Zion Nuclear Power Station, Units 1 and 2
Facility Operating License Nos. DPR-39 and DPR-48
NRC Docket Nos. 50-295 and 50-304

Subject: Response to Summary of May 4, 2023, Clarification Meeting Regarding the Partial Site Release Request for the Zion Nuclear Power Station, Units 1 and 2

Attachment to ZS-2023-017

Supplemental Information

Figure 1 – Survey Units Surveyed with DRP DQOs

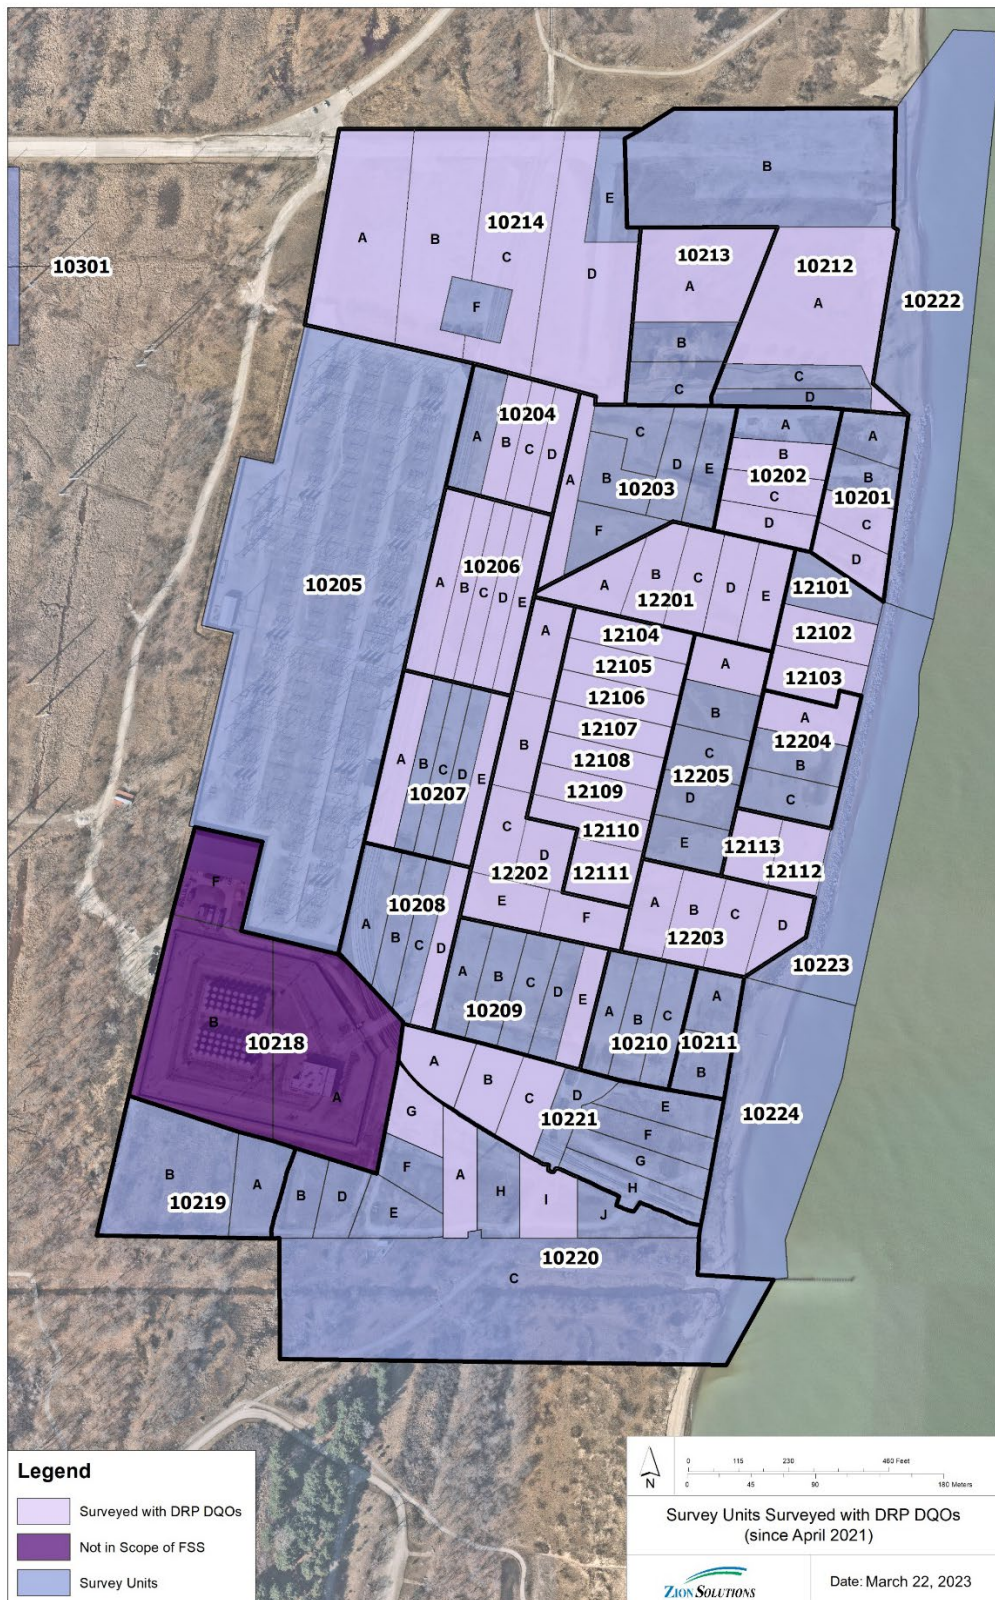
Provide a consolidated description of which survey units were surveyed using the DRP DQOs [discrete radioactive particle data quality objectives]. At a minimum, please clarify which survey units in the power block, haul path, and loadout areas were surveyed using DRP DQOs. As part of this description, indicate the survey methodology used (e.g., hand scanning vs towed array). Also, please indicate approximately what fraction of the survey unit was surveyed using the given survey technique.

Figure 1 provides a visual depiction of the survey units that were surveyed with DRP DQOs. (Although there are 65 survey units listed above, there are only 59 shown on Figure 1 because some of the survey units fall into more than one of the categories described above.)

Figure 2 – Basement Structures with 3 ft of Clean Soil Cover

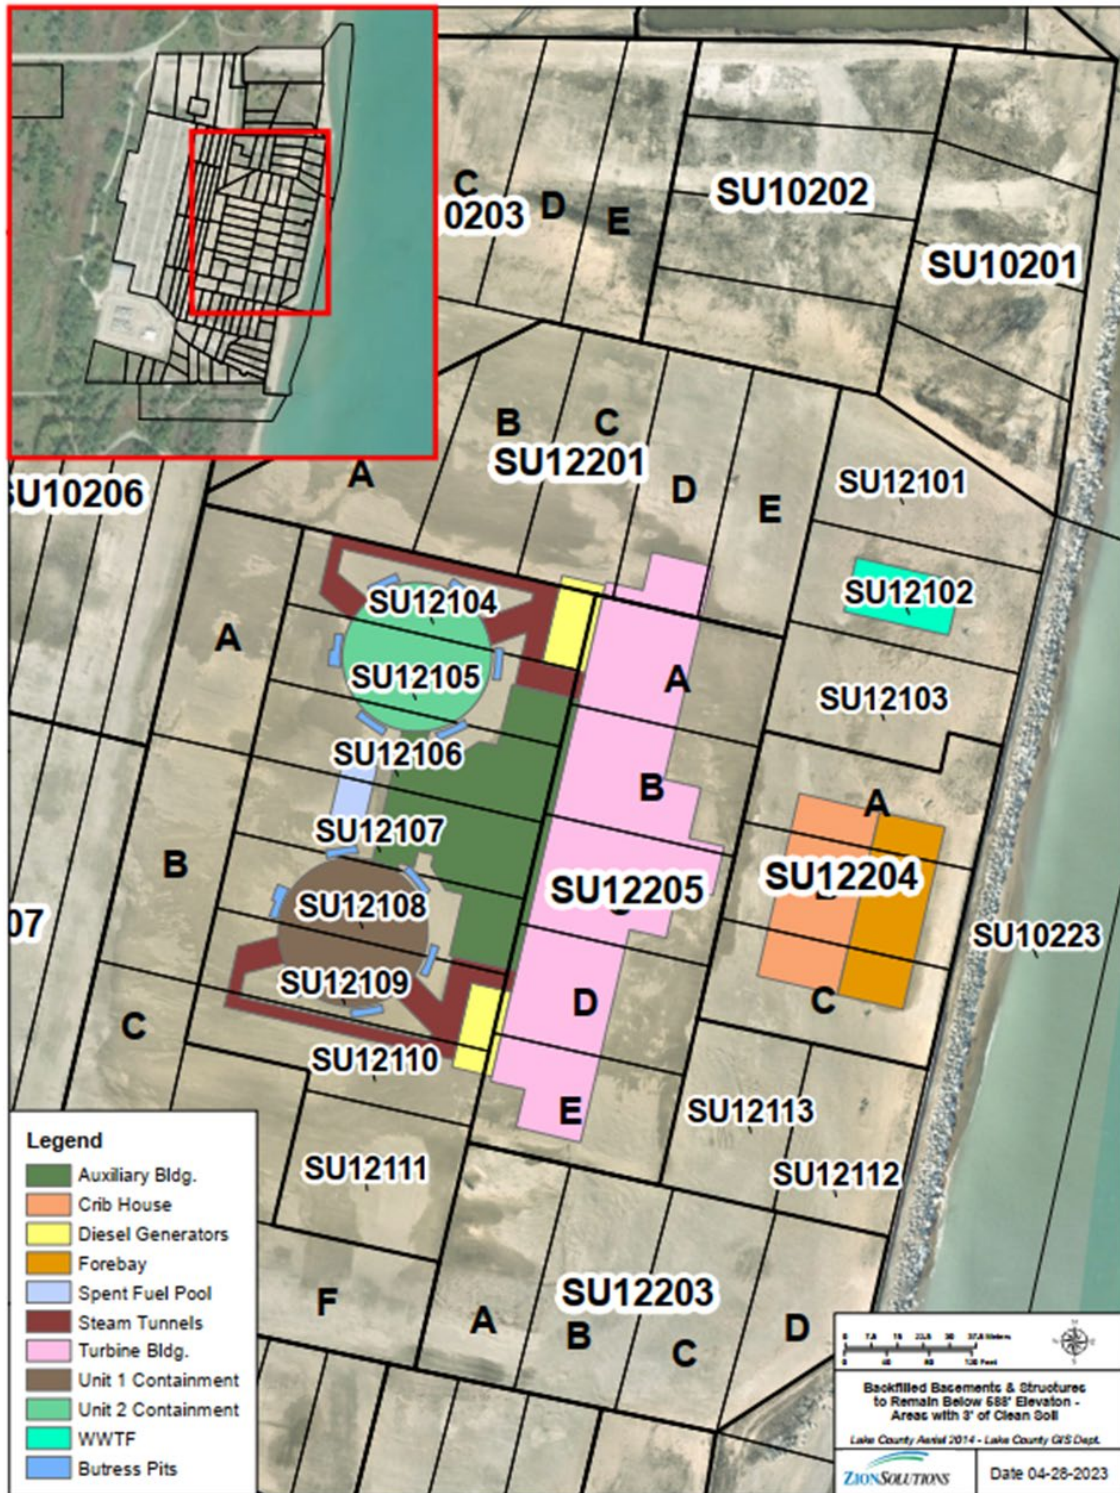
- a) Which areas of the site was additional soil cover placed on?*
- b) Were the areas surveyed prior to placement of the cover? If so, please provide a description of the survey type. Also, please summarize the results of the surveys.*
- c) Clarify what is meant by 'cover' and confirm that the 3-ft cover was placed in compliance with the LTP [license termination plan].*
- d) Did the soil used for the 3-ft cover clean originate from off-site? Please identify which parts of the site were covered with clean soil from off-site.*
- e) Identify any areas that were covered with less than 3 ft of cover.*
- f) Describe the surveys performed prior to placing backfill material in excavations and the source of the material.*

- a) The areas where 3 ft of clean soil cover was required per the LTP are the end-state basements. Figure 2 shows the end-state basements that received the 3 ft of clean soil cover.
- b) The surveys that were performed prior to backfill and covering of the basements were the FSSs of the below-ground structural surfaces, embedded pipe, and penetrations. After completion of FSS in each basement, personnel from the Oak Ridge Institute for Science and Education (ORISE) performed an independent verification survey prior to backfill.

- d) The soil used for the 3 ft of clean soil cover over basements was imported from an off-site source. Figure 2 shows the end-state basements that received the 3 ft of clean soil cover.
